UNITED STATES PATENT AND TRADEMARK OFFICE

Office Action Summary	Application No. 10/714,232	Applicant(s) BALLANTINE ET AL.	
	Examiner Raymond Alejandro	Art Unit 1745

DETAILED ACTION

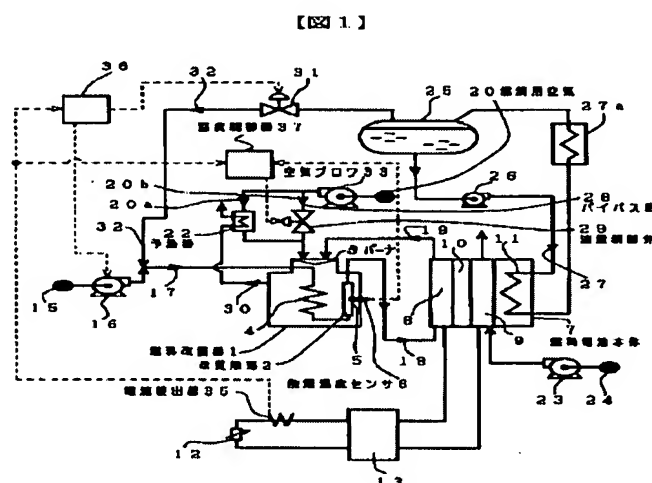
Figure 1 of the JP'365 illustrates a fuel cell power generating device (TITLE/ FIGURE 1) including a fuel cell 7 respective oxidant supply 24 and fuel supply 18 (FIGURE 1) which are provided for power generation; and a controller 36 for controlling fuel cell operating parameters (FIGURE 1). Particularly, controller 36 controls flow rate control valve 29 in response to conditions sensed by both temperature sensor 6 (heat sensor) and a current detector 35 (power

demand sensor), and which is further adjusted according to a load current value of the fuel cell main body 7 (Abstract/Constitution).

Particularly, the JP'365 discloses that controller 36 controls flow rate control valve 29 in response to conditions sensed by both temperature sensor 6 (heat sensor) and a current detector 35 (power demand sensor), and which is further adjusted according to a load current value of the fuel cell main body 7 (Abstract/Constitution). *Thus, control of at least fuel flow is based on the sensed temperature and the measured current and the load current value of the fuel cell. In this case, it is noted that the controller of the JP'365 is capable of performing the claimed function based on the particular sensed conditions. Thus, the controller of the JP'365 inherently controls the fuel cell system as instantly claimed in claims 52-55 and 57-58. In other words, the examiner is asserting inherency based on the structural and functional similarities between the disclosed controller and applicant's controller. In re Schreiber, 128 F.3d 1473, 44 USPQ2d 1429 (Fed. Cir. 1997).*
